**re: Grading Plan Review**  
**Proposed Apartment Building**  
3080 Navan Road – Ottawa, Ontario

**file: PG6527-MEMO.01 Revision 2**

## **Grading Plan Review**

- Grading Plan – 3080 Navan Road (Rhythm Apartments), City of Ottawa – Project No. 122180 – Drawing No. 122180-GR Revision 5, dated April 22, 2024.

# PG6527-MEMO.01 REVISION 2 - PROPOSED LIGHTWEIGHT FILL PLAN

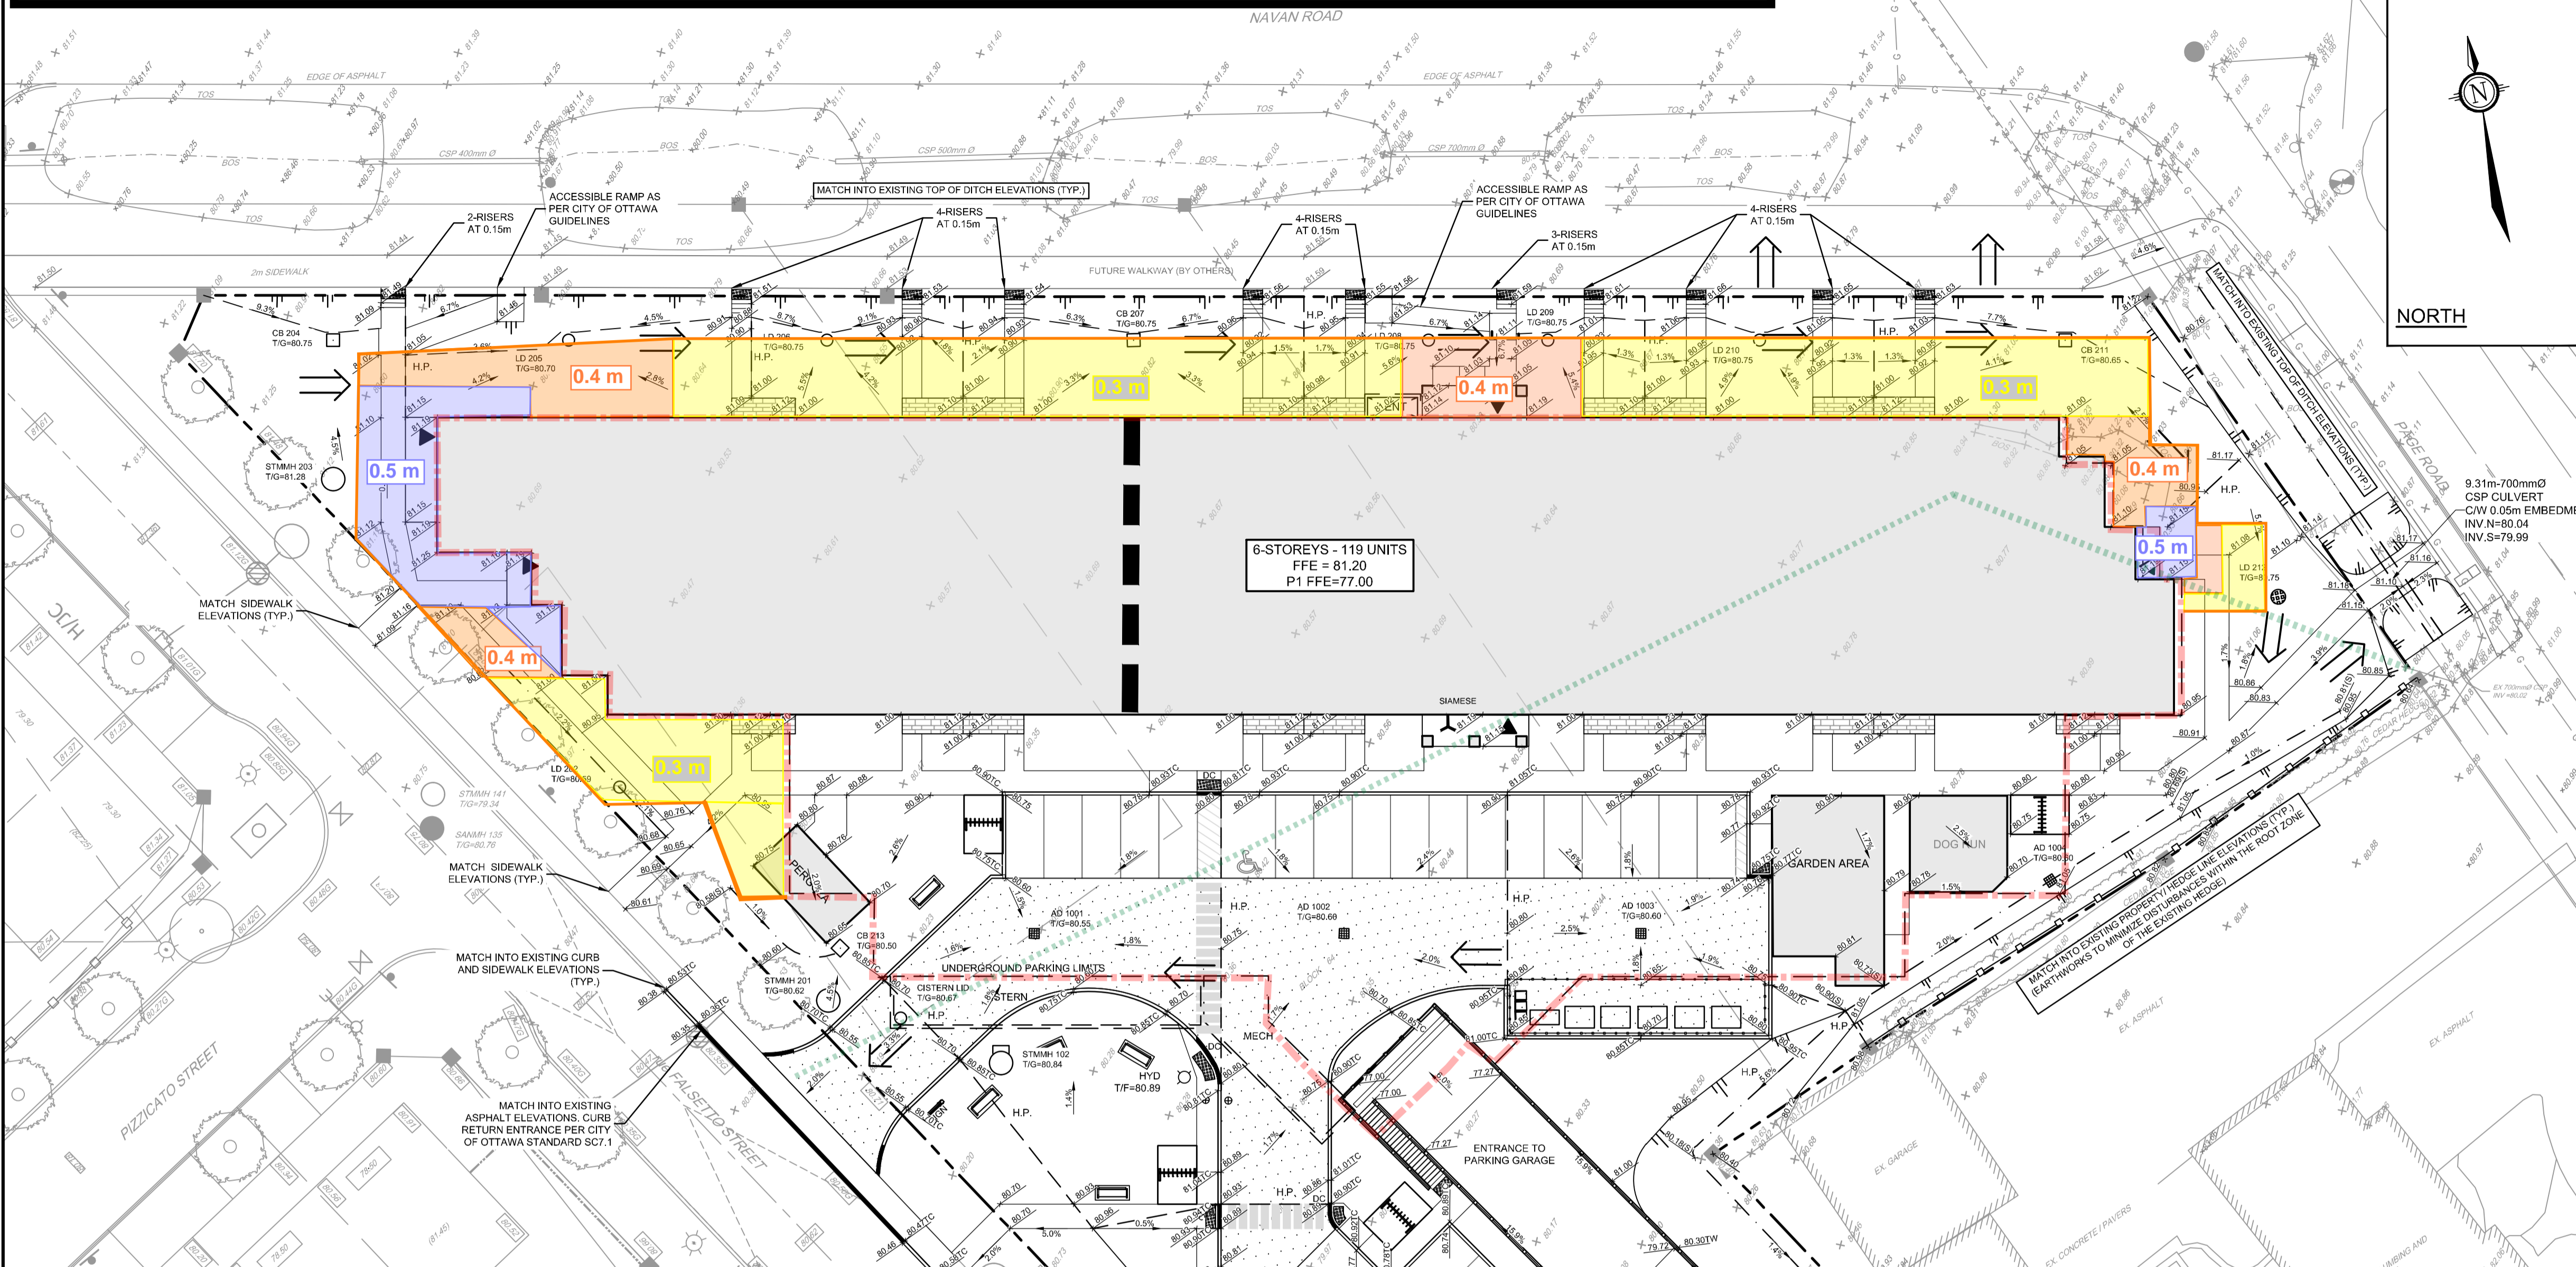
However, in the north corner of the site, grade raise exceedances of up to approximately 0.5 m are currently proposed for the landscaped and hardscaped areas located within 5m of the building footprint. Where these grade raise exceedances are proposed, lightweight fill (LWF) is recommended to mitigate excessive settlement. The attached figure PG6527-Figure 1 – Lightweight Fill Recommendations indicates the approximate LWF locations and thicknesses which are recommended.

Overall, the LWF should consist of EPS (expanded polystyrene) geofoam blocks, which allow for raising the grade without adding a significant load to the underlying soils. For this application, EPS Type 15 should be used and extended a minimum of 5 m beyond the building footprint in all directions where it is being recommended to be used.

It should also be noted that EPS is difficult to use under the groundwater level, as it is buoyant, and it must be protected against potential hydrocarbon spills. Based on this, the placement of lightweight fill should be planned to provide a minimum of 1.5 m of backfill upon its surface. The lightweight fill layer is recommended to be placed a minimum of 500 mm above any perimeter drainage sleeves/pipes provided to the main building structures foundation and the associated open-graded stone layers.

The lightweight fill should be placed upon a flat soil surface. Therefore, the soil should be compacted to be relatively smooth and flat prior to installation. Consideration may be given to placing a thin layer of sand or stone dust to attain a relatively smooth/flat surface for placement. The entire lightweight fill layer footprint is recommended to be covered with a layer of polyethylene (taped at seams) extending between the building footprint and outer edge of the layer and extending below its surface by a minimum of 100 mm at all edges of the lightweight fill layer.

If the lightweight fill will be located in an area of landscaping, the placement of the layer should be planned to provide a minimum 500 mm of soil cover be provided to the lightweight fill layer for grass and associated vegetation can establish overtop the lightweight fill.

The placement of all lightweight fill should be reviewed at the time of placement by Paterson personnel. It is also advised a brief pre-construction meeting to be held between Paterson and the construction team to discuss placement prior to the installation. As an alternative to the use of LWF, the areas of the proposed grade raise exceedances could be preloaded to the finished grade, or surcharged, using fill materials. This option, however, would require allowing an extensive period of time for the settlement to occur prior to construction, which may not be compatible with construction timelines. Additional information can be provided if this option is being given consideration.
